STATE OF NORTH CAROLINA
DEPARTMENT OF TRANSPORTATION

SUBJECT: Permit Modification Request for TIP No. R-2809B and C, Wake County, NC DOT Division 5, Federal Aid No. STP-98(1), State Project No. 8.1402501, USACE Action ID 199601836, and DWQ Project No. 010550, \$475 Debit Work Order WBS Element 34503.1.1

R-2809, Wake Forest Bypass, Wake County

SHEET 7 OF 12 REVISED 5/05

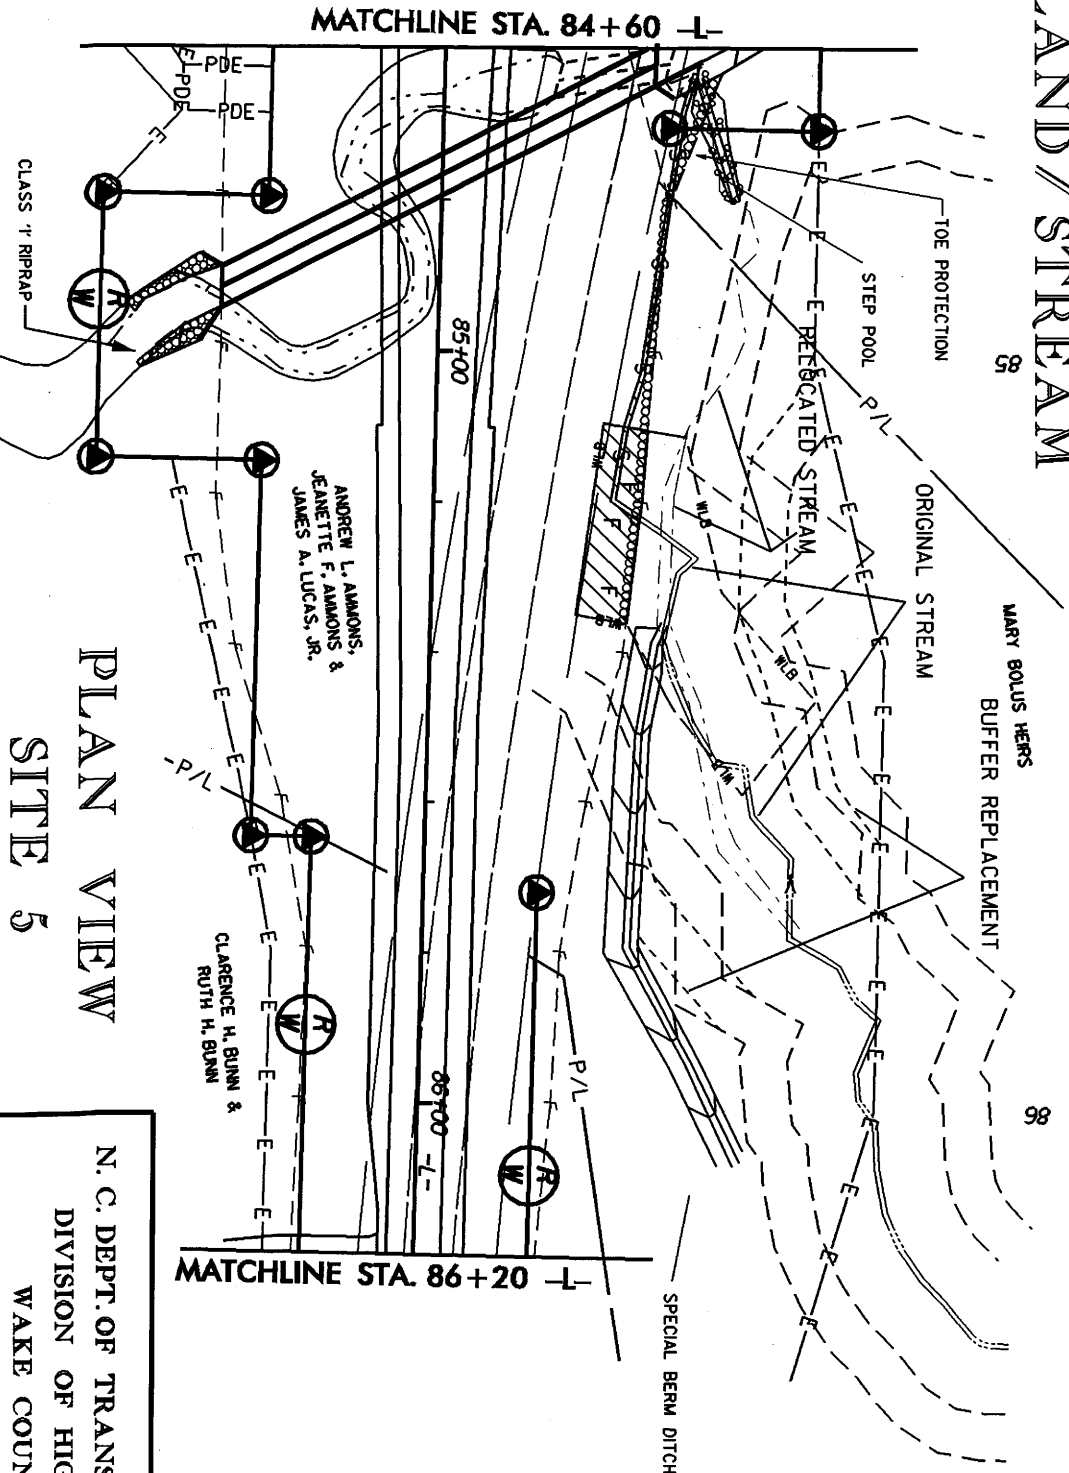
R-2809C Site 4, Sheet 7 of 12

Station -L-84+60

The bank at the culvert inlet and outlet was re-graded so the fill from the roadway could tie into the natural elevation of the stream bank. Rip rap was also installed on 63 feet of the bank for bank stability where the bank was re-graded

Impact change: Increase of 63 feet of Permanent Stream Impacts

Increase of 30 feet of Temporary Stream Impacts

Decrease of 46 feet of channel relocation using natural channel design

SHEET 8 OF 12 REVISED 8/05

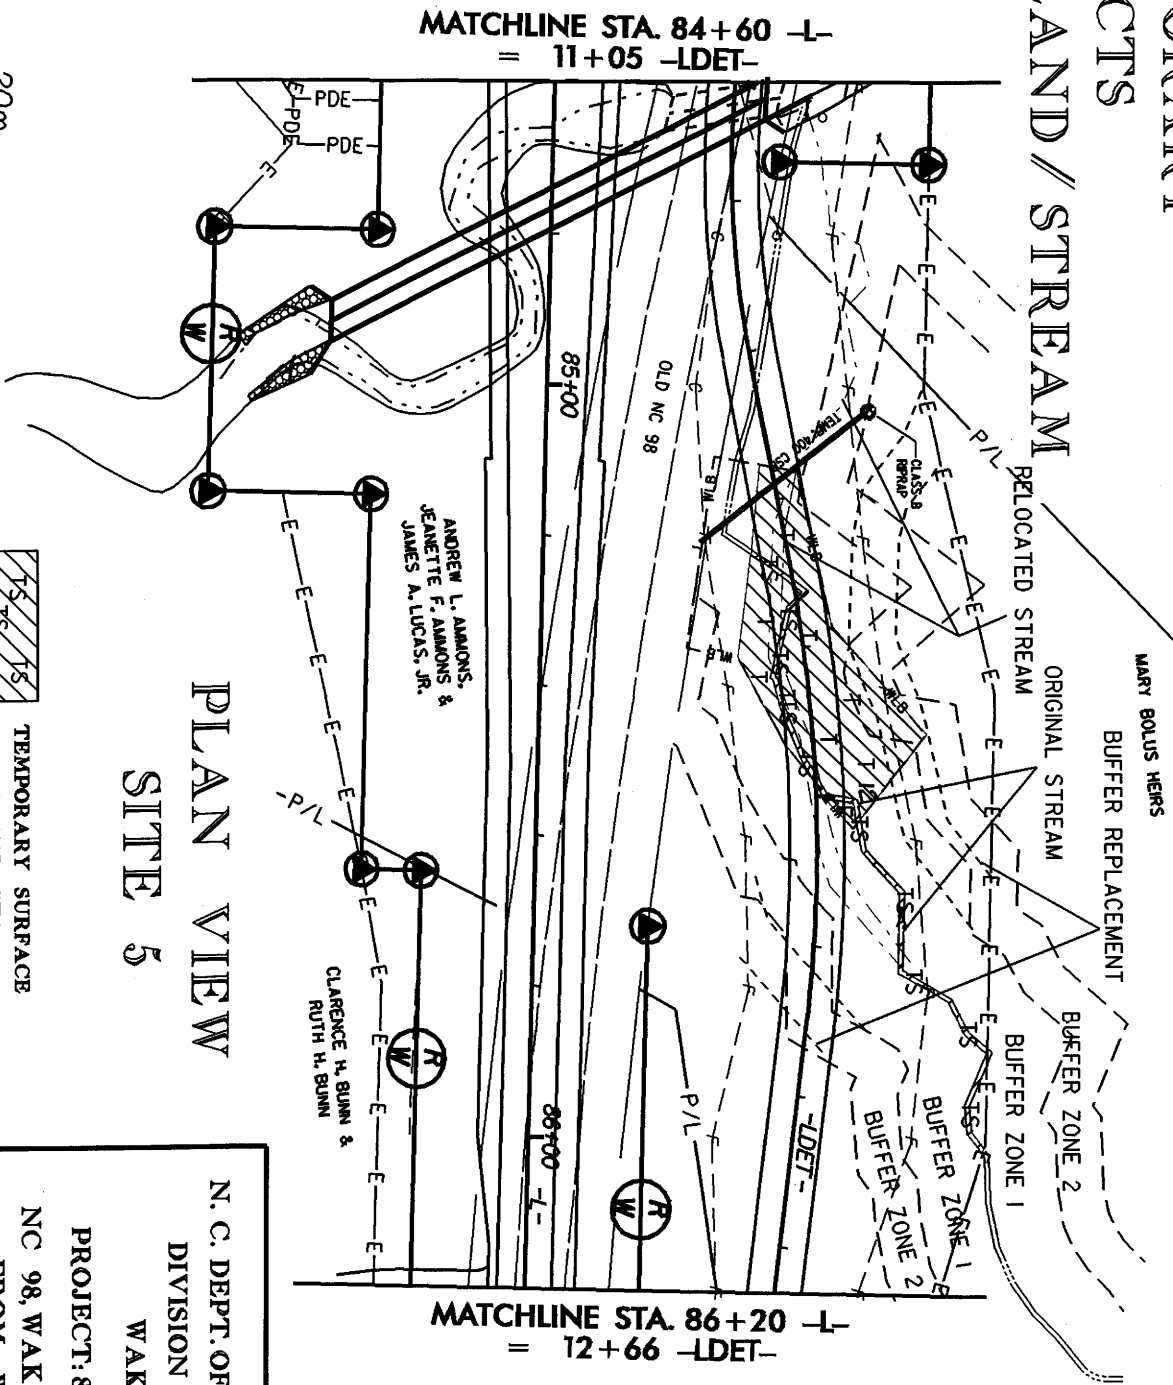
R-2809C Site 5, Sheet 8 and 8B of 12

Station -L-85+20

Construction access to build the temporary lateral base ditch required use of the entire construction easement. A step pool was also constructed to tie in the Unnamed Tributary at the culvert inlet at Station 84+80-L-. When the original permit application was submitted, temporary stream impacts were not calculated on the Impact Summary Sheets. If the impacts were reported at that time they would have been estimated to be 197 feet. Total temporary impacts now total 322 feet.

Impact change: Increase of 125 feet of Temporary Stream Impacts
